IEEE P 802.20™ V9

Draft 802.20 Permanent Document

<802.20 Requirements Document – Ver. 9>

Figure 3.1

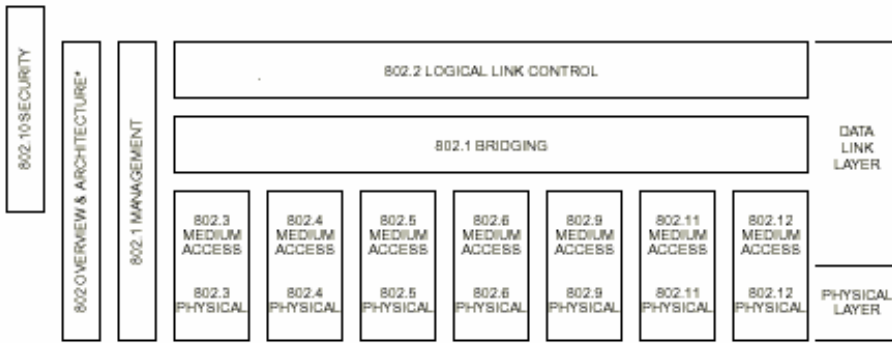
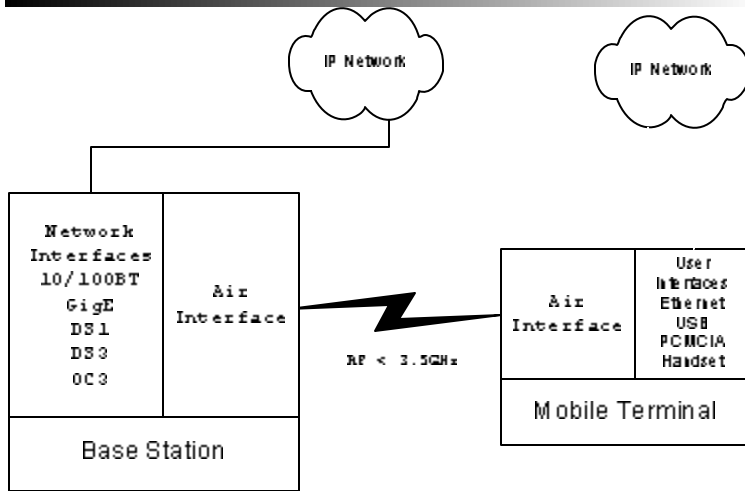
1 *Editors Note Diagram in Appendix B*
 2 *Action: Change the notations in the bubbles to point to the relevant section of the text (or*
 3 *remove the bubbles).*
